Access Compliance Report

Public Rights-of-Way

(Curb Ramps)

Intersection ID: 21348	Main Street: CARMEL_RD	Cross Street: SHARON_VIEW_RD	Location: SE
ADA ID: 8F399CACAD05	Ramp Type: Perpendicular	Initial Pass/Fail: Fail	Overall Compliance: No
		Severity Score: 26.25

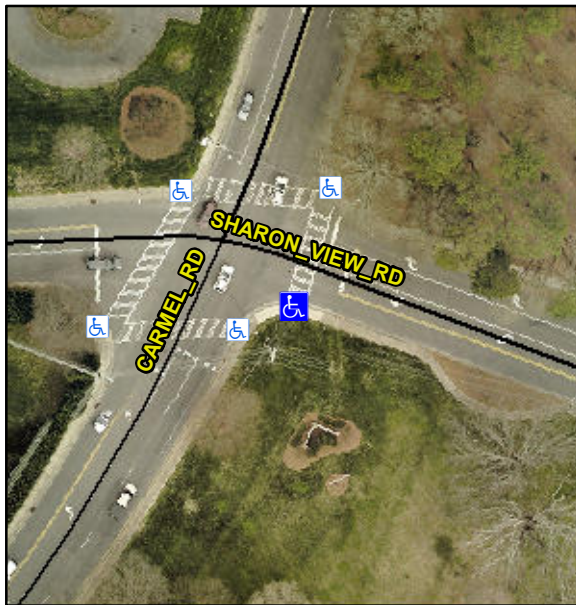
Not Found, R304.2.2, R304.5.3

Compliance	Description	Data	Compliance	Description	Data
N/A	Ramp Length (in)	62.0	No	Ramp Slope (%)	12.6
Yes	Ramp Width (in)	48.0	No	Ramp XSlope (%)	3.9
N/A	Flare Type LT	N/A	N/A	Flare Type RT	N/A
N/A	Flare Slope LT (%)	N/A	N/A	Flare Slope RT (%)	N/A
N/A	Flare Traversable LT?	N/A	N/A	Flare Traversable RT?	N/A
N/A	Landing Length (in)	N/A	N/A	DWS Provided?	N/A
N/A	Landing Width (in)	N/A	N/A	DWS Contrast?	N/A
N/A	Landing Slope (%)	N/A	N/A	DWS Length (in)	N/A
N/A	Landing X Slope (%)	N/A	N/A	DWS Full Width?	N/A
N/A	Landing Curb? (Y/N)	N/A	N/A	DWS Offset (in)	N/A
N/A	Shared Landing?	N/A			
N/A	Gutter Ponding?	N/A	N/A	Gutter Slope (%)	N/A
N/A	Gutter Lip Ht (in)	N/A	N/A	Gutter X Slope (%)	N/A
N/A	Painted X Walk1?	Yes	N/A	Painted X Walk2?	N/A
	X Walk 1 Direction	To NE		X Walk 2 Direction	N/A
N/A	X Walk 1 Width (in)	111.0	N/A	X Walk 2 Width (in)	N/A
	X Walk 1 Slope (%)	5.8		X Walk 2 Slope (%)	N/A
	X Walk 1 X Slope (%)	1.3		X Walk 2 X Slope (%)	N/A

Remove & Replace Entire Ramp.
